2017/7092/P - 85 Gloucester Avenue

Delegated Report (Members' Briefing)		Analysis sheet		Expiry Date:	16/02/2018
		N/A		Consultation Expiry Date:	22/02/2018
Officer			Application Number(s)		
Matthias Gentet			2017/7092/P		
Application Address			Drawing Numbers		
85 Gloucester Avenue LONDON NW1 8LB			Refer to draft decision notice.		
PO 3/4	Area Team Signature	C&UD	Authorised Officer Signature		
Proposal(s) Erection of a two-storey lower and ground floor infill rear extension with rooflight, conversion of front vaults into wc/utility room, addition of metal access staircase to front lightwell and raising of the garden level.					
Recommendation(s):		Grant conditional Planning Permission			
Application Type:		Householder Application

Erection of a two-storey lower and ground floor infill rear extension with rooflight and associated alterations to fenestration of existing rear extension, conversion of front vaults into wc/utility room and addition of metal access staircase to front lightwell, all in connection with single dwelling (Class C3).

1. Bird's eye view of the rear streetscape including the current extension

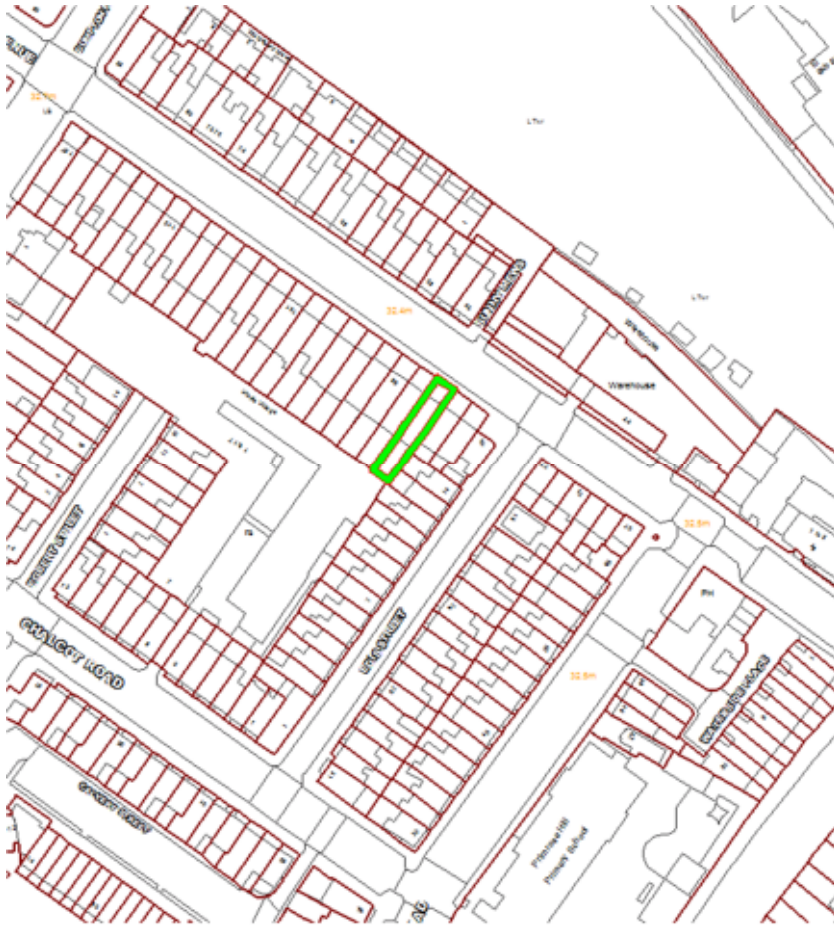
Existing rear extension. Existing fenestration to be slightly altered

Existing single storey extension to be replaced with 2-storey infill extension

The original proposed prior to amendments being sought

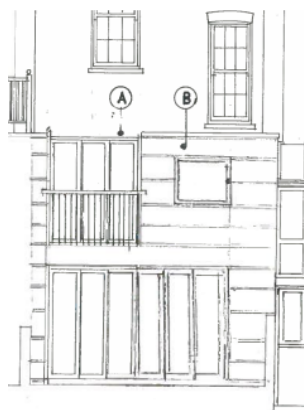
- 2.4 In the originally proposed scheme, there was no visual separation between the new extension and the closet return. The extension read as one solid mass. Incised stucco would not be traditionally found to the rear of terraced buildings and the use of incised render across the full width of the rear extension would appear incongruous in relation to the host building and the rest of the terrace.

- 2.5 It also exacerbated the lack of differentiation between the old and new elements of the proposal and gives a strong horizontal emphasis at odds with the architectural language of the host building.

- 2.6 Concerns were also raised in respect of the originally proposed fenestration which failed to relate to the proportions or architectural style of the fenestration above and the use of aluminium, not being a traditional material.

- 2.7 The Juliet balcony and sliding screen with structural glass roof light were also considered to appear as incongruous features, at odds with the distinct architectural character of the terrace.

2.10 Amendments were therefore sought and the revised proposal consist of the following:

- (i) Retention of the existing details of rear extension (brick work, timber frame sash windows);
- (ii) Reduction in size of the proposed first floor windows on the infill extension;
- (iii) Reduction in size of the proposed ground floor sliding doors to match the above proposed window;
- (iv) Infill extension to be slightly set back, thus subordinate to the existing extension;
- (v) Replacement of glass roof with pitch roof light
- (vi).Extension to be made of bricks with timber frame sliding doors/windows
- (vii) Removal of the bin/cycle store
